October 28, 2024

PROJECT NAME: MSP 8009-1274-14

APPLICATION: MINOR SITE PLAN #31904

TRENCHED DRAIN FIELD W/ IN GROUND NITROGEN REDUCTION BIO FIELD SECTION

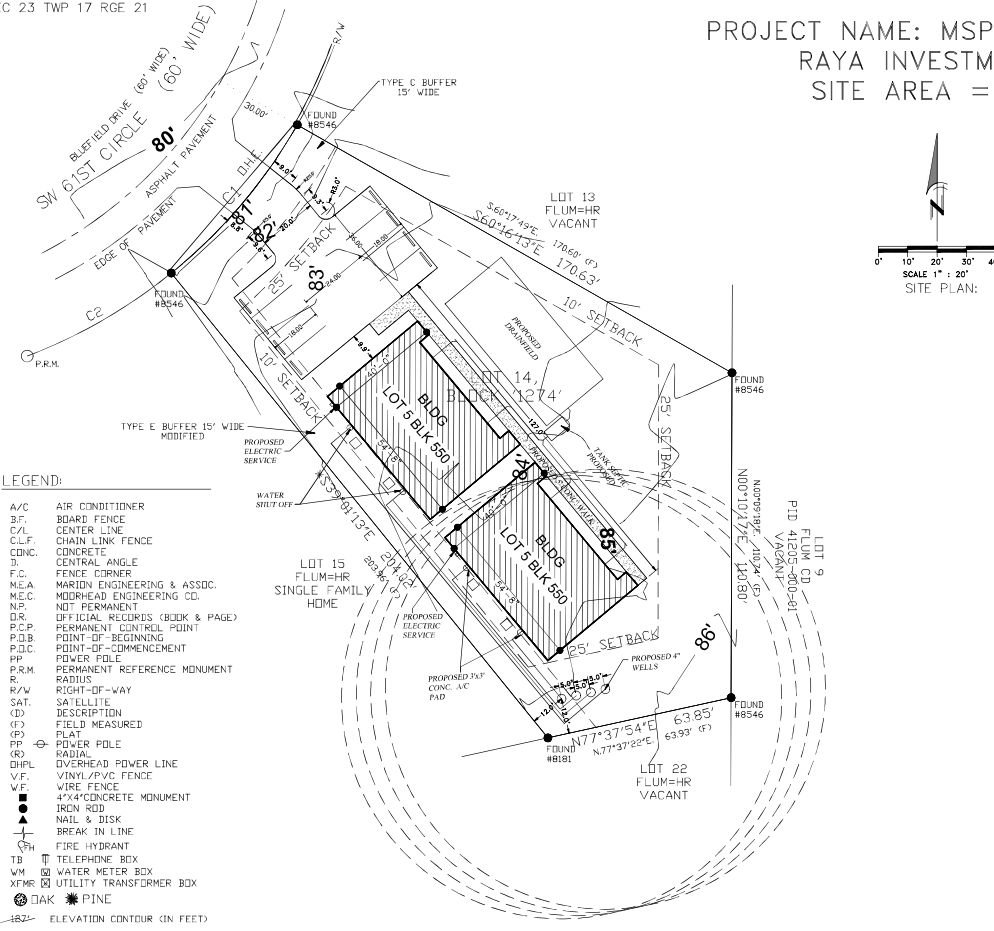
- 4 DEPARTMENT: DOH - ENVIRONMENTAL HEALTH
REVIEW ITEM: Additional Health comments
STATUS OF REVIEW: INFO
REMARKS: Apply for all septic and well permits through the Department of Health in Marion County. For future reference waste water calculations should be based off of 62-6 F.A.C. not 64E-6.

LANDSCAPE PLAN		DATE:	8-15-24	DESIGN:	NCA	PROJ. JAMES TER...	SHEET
NO.	INITIAL COUNTY COMMENTS	10-25-24	SCALE:	AS SHOWN	DRAW:	MS	JOB NUMBER: 24-058
NO.	REVISION	DATE	APPROVER:	NCA	CHECK:	NCA	FILE: RAYA.MHOR...

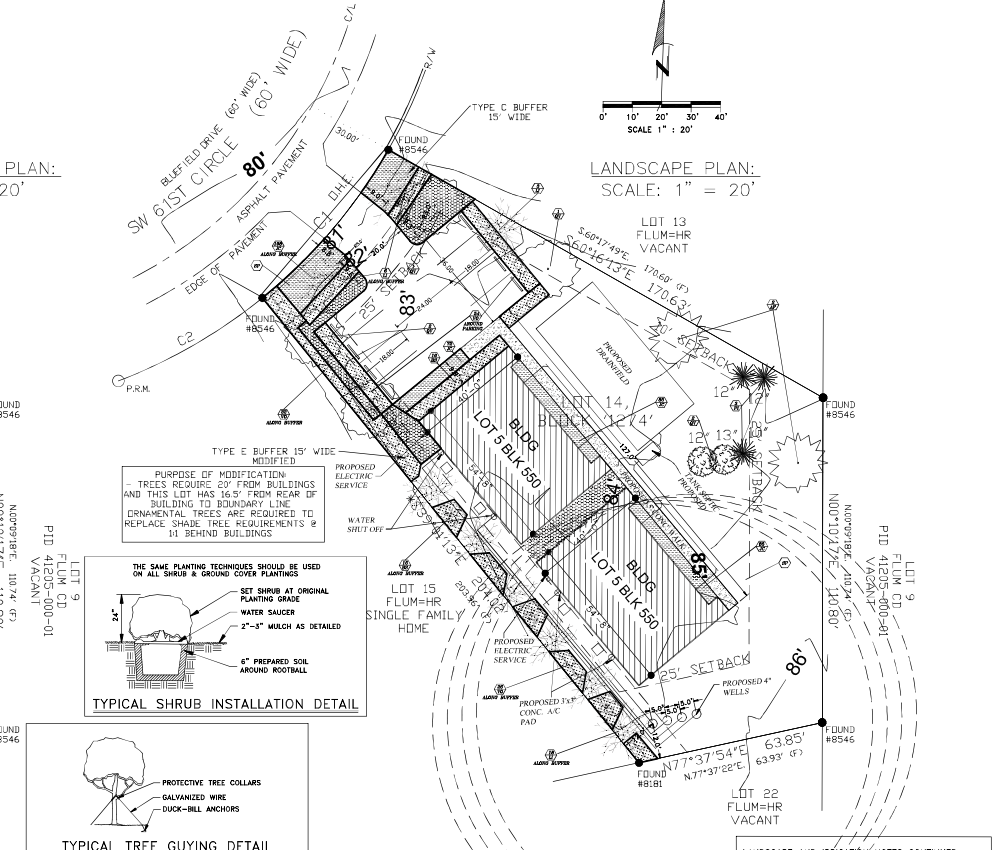
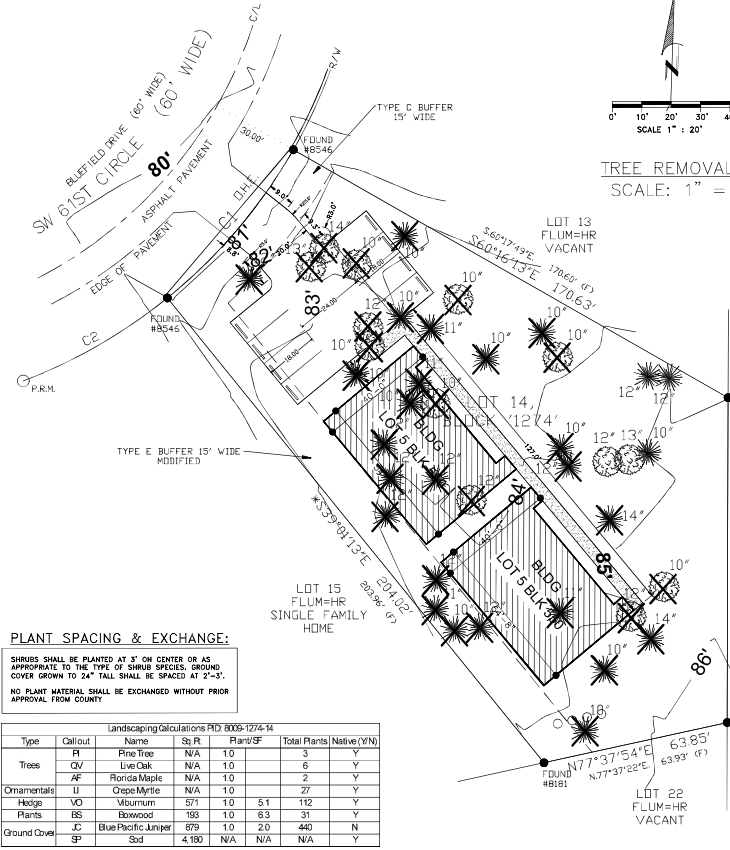
- 15 DEPARTMENT: LSCAPE - LANDSCAPE DESIGN AND IRRIGATION
REVIEW ITEM: 6.8.2 - Landscape plan requirements (details, schedule, calculations, notes)
STATUS OF REVIEW: NO
REMARKS: 1. Show plant spacing, not sq ft in schedule 2. Provide common and scientific names of plants 3. Remove plants not being used from schedule, very confusing 4. Landscape and irrigation plans shall be signed and sealed by design professional (6.2.1 & 6.9.2)

- 17 DEPARTMENT: LSCAPE - LANDSCAPE DESIGN AND IRRIGATION
REVIEW ITEM: 6.8.6 - Buffers
STATUS OF REVIEW: NO
REMARKS: 1. Show shrubs and groundcovers in Type C buffer, plan only has groundcover 2. Why is Type E buffer modified? waiver required to modify 3. Type E buffer does not comply with canopy tree requirements - 4 shade trees per 100 LF and double staggered shrubs.

- 18 DEPARTMENT: LSCAPE - LANDSCAPE DESIGN AND IRRIGATION
REVIEW ITEM: 6.8.7 - Parking areas and vehicular use areas
STATUS OF REVIEW: NO
REMARKS: 1. Sweet viburnum is too close to parking area, pull away from edge 2-3' 2.

Section & Title of Code (be specific): 6.8.6 Buffering
Reason/Justification for Request (be specific): Type A buffer modification is not possible due to space between the buildings and the west boundary line. The distance between boundary and building is less than 20'. We can We can replace / exchange the 4 trees per 100 lf with ornamental trees at 1 to 1. In addition buried utilities service can not be impaired by the tree roots.
